Preservation Department – Item 1, LPC-22-08731

**6301 12th Avenue, aka 6301-6323 12th Avenue, 1202-1216 63rd
Street, and 1201-1215 64th Street – Angel Guardian Home –
Individual Landmark
Borough of Brooklyn**

LPC-22-08731: 6301 12th Avenue, Angel Guardian Home - Individual Landmark

PUBLIC MEETING SCOPE 09/20/2022

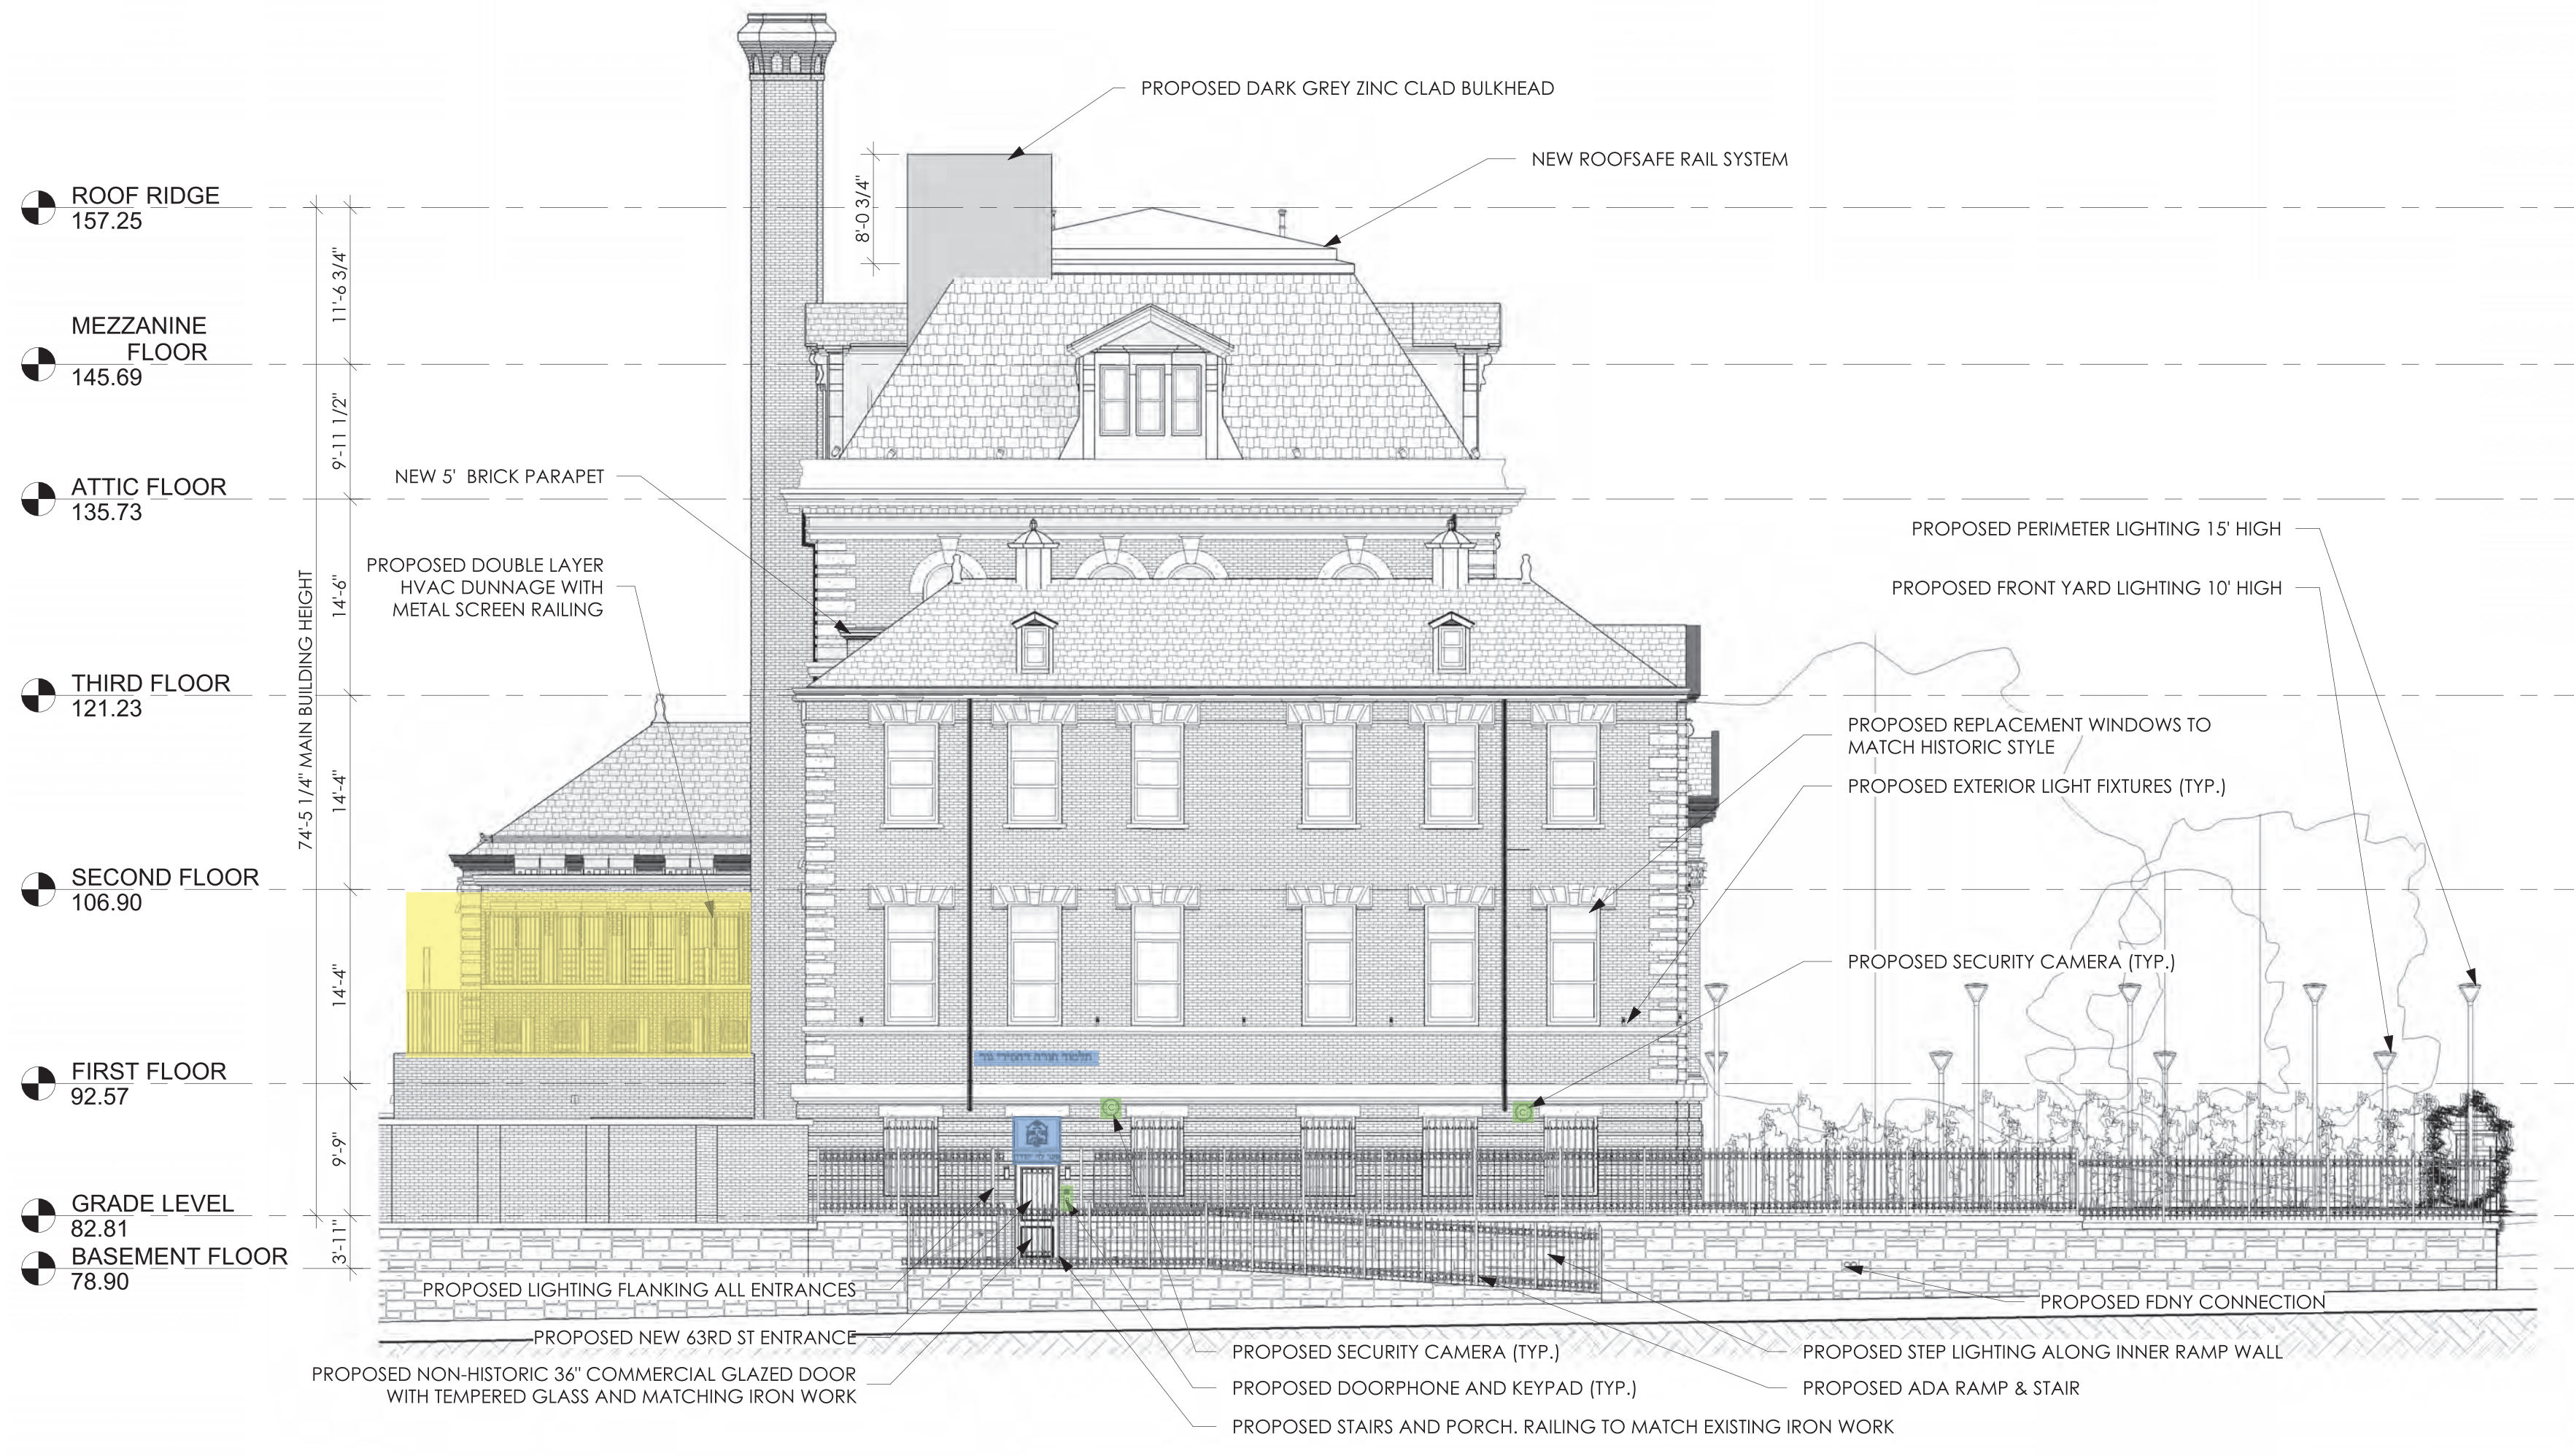
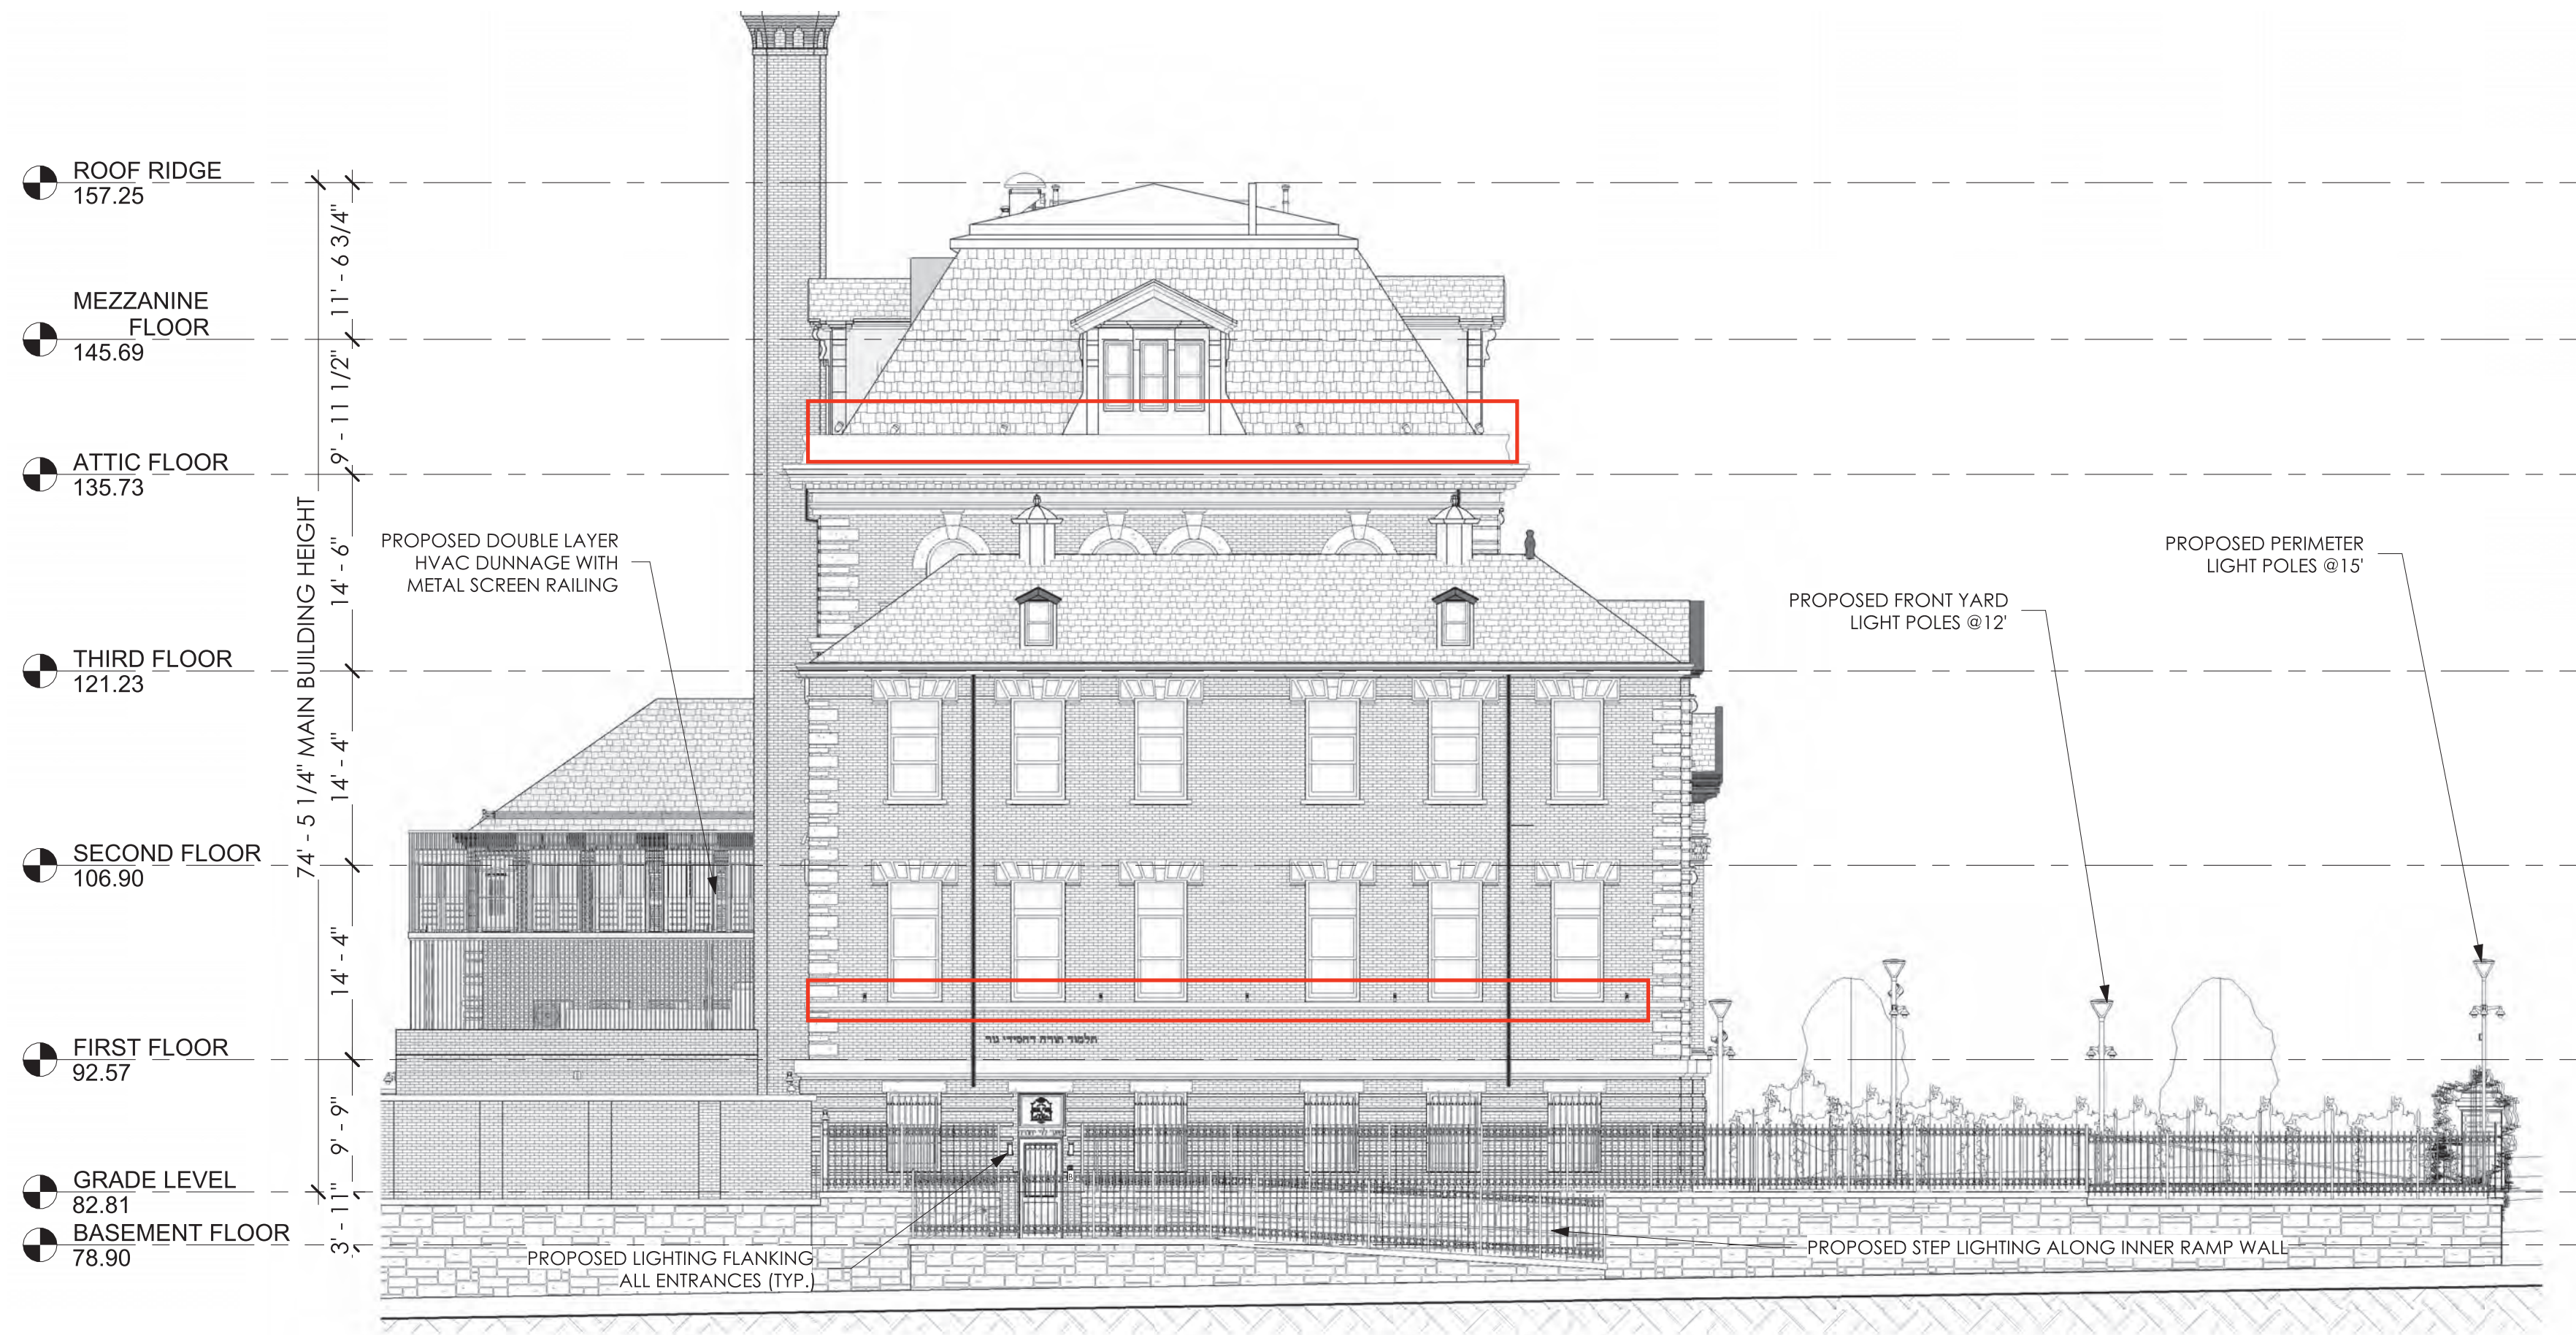
- CHANGES:**
- TREE IN FRONT OF 63RD ST WING TO BE REMOVED
 - ADDITIONAL TREES TO REMAIN
 - REVISED LIGHT POLE PLACEMENT
 - MAIN BUILDING FACADE LETTERING SHORTENED
 - LETTERING ON ARCH REMOVED

**63RD STREET
REVISED ELEVATION**

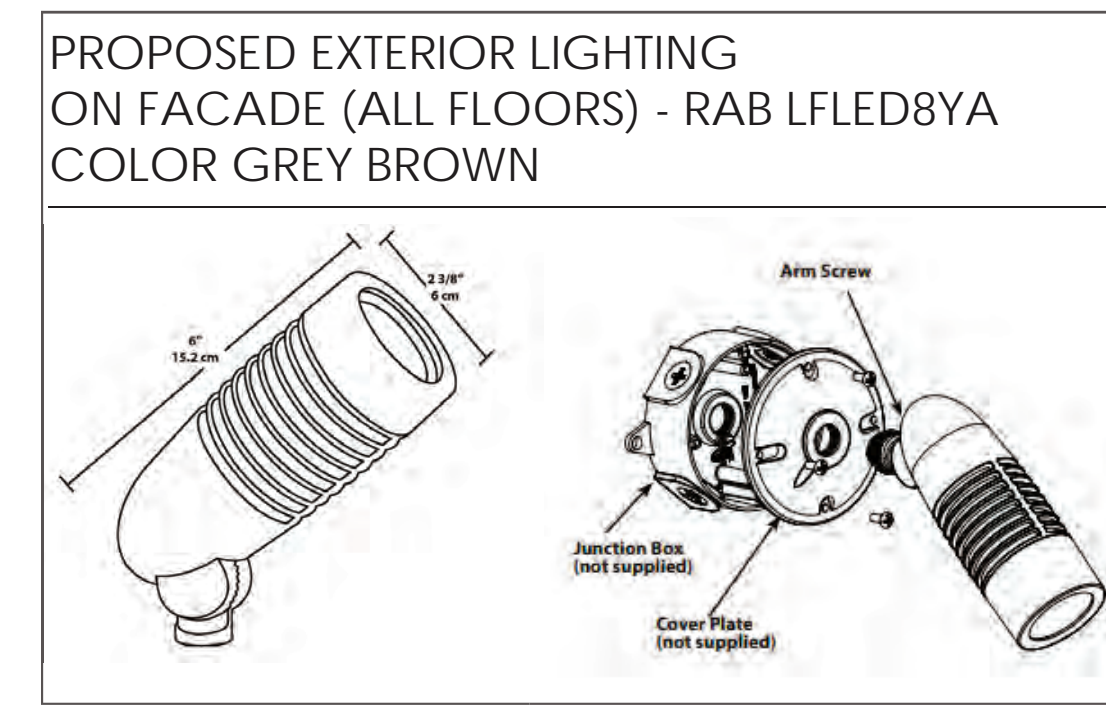
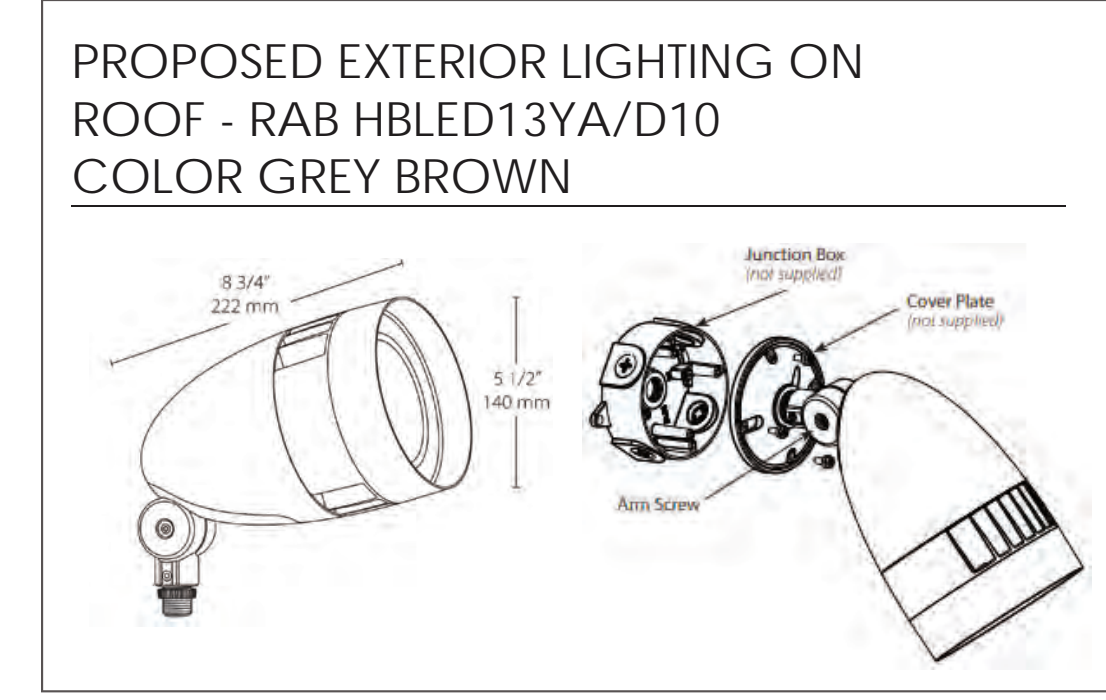
- CHANGES:**
- LIGHTING, SPEAKER, AND SECURITY CAMERA FIXTURES REMOVED
 - DOORS REVISED TO MATCH HISTORIC IMAGES
 - ELEVATOR BULKHEAD LOWERED
 - MECHANICAL DUNNAGE WIDENED
